U.S. Patent Application Serial No. 09/822,617
Attorney Docket No. 03226/090001; P5702

APPLICANT(S) : Daniel LUCHAUP ART UNIT: 2654
SERIAL NO. : 09/822,617 EXAMINER: Abul K. Azad
FILED : March 30, 2001
TITLE : GENERAL REMOTE TRANSLATOR

SUBMISSION OF FORMAL DRAWINGS

FIG. 1

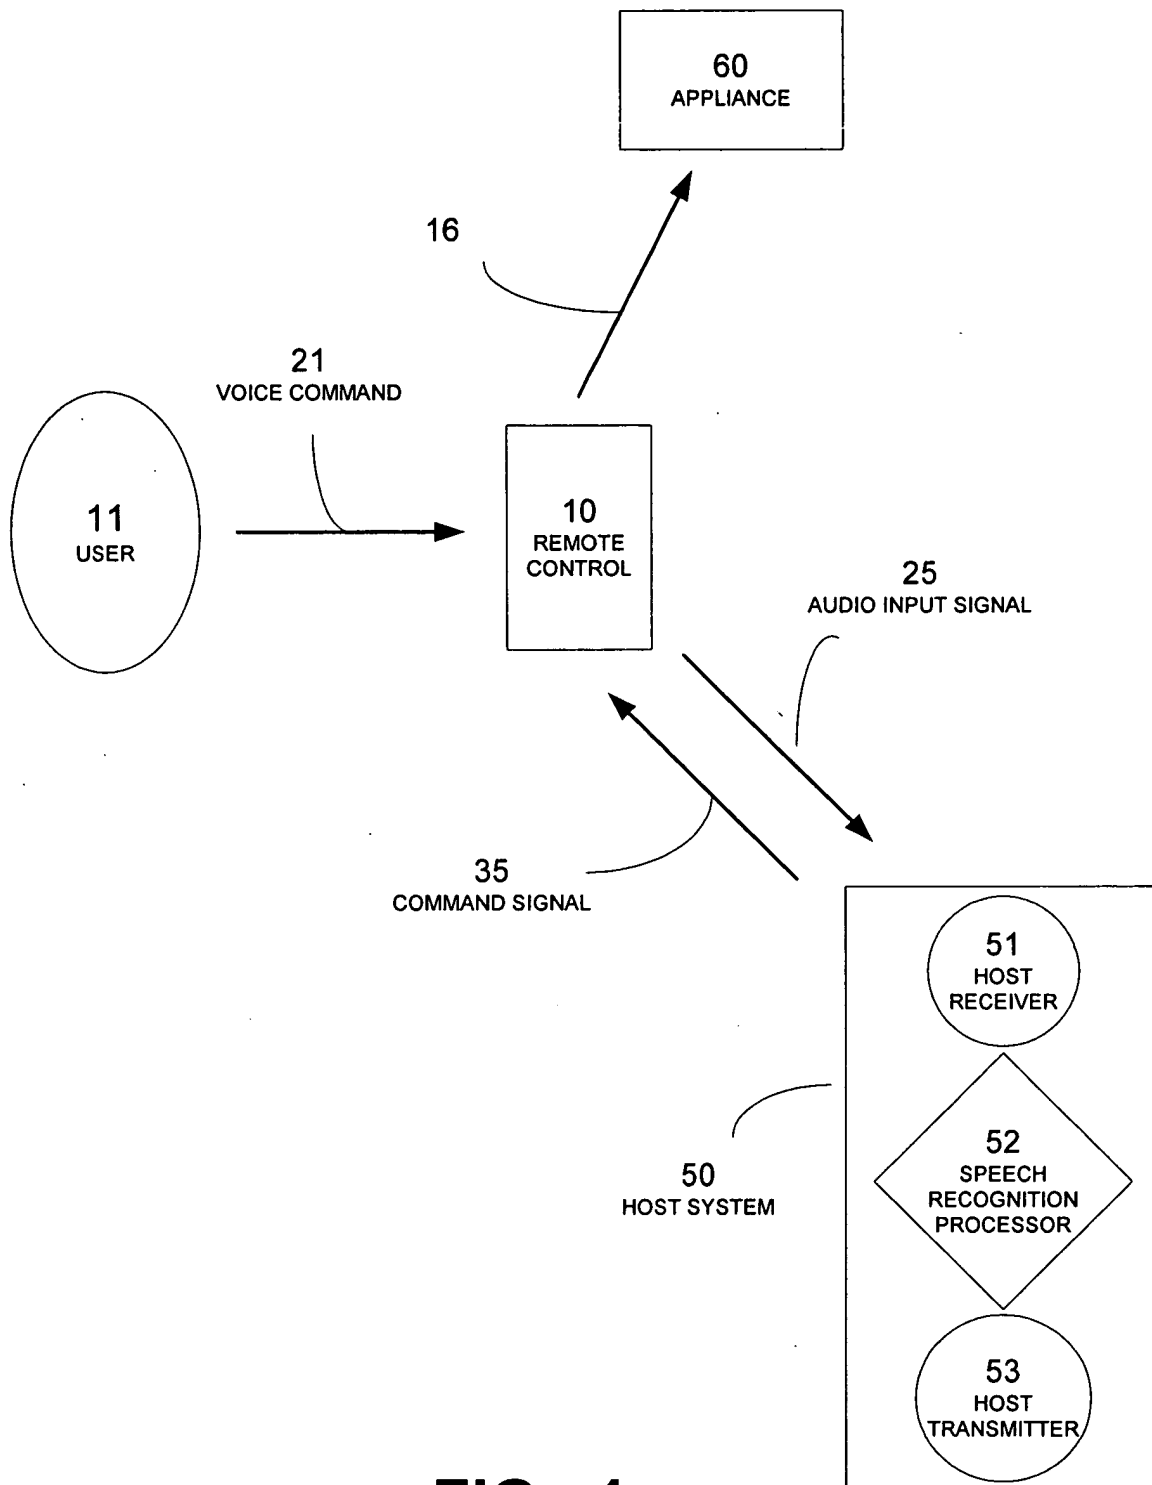
Please amend FIGs. 1, 2A, 2C, and 4 as shown in the attached replacement sheets. FIG. 1 now includes words to describe each element in the drawing. FIGs. 2A and 2C have been amended in item 15 to replace “voice recognition processor” with “speech recognition processor.” FIG. 4 has been amended in step 73 to replace “voice recognition” with “speech recognition.” Applicant submits that these replacement figures are formal. Also, a separate letter to the Official Draftsperson is enclosed.
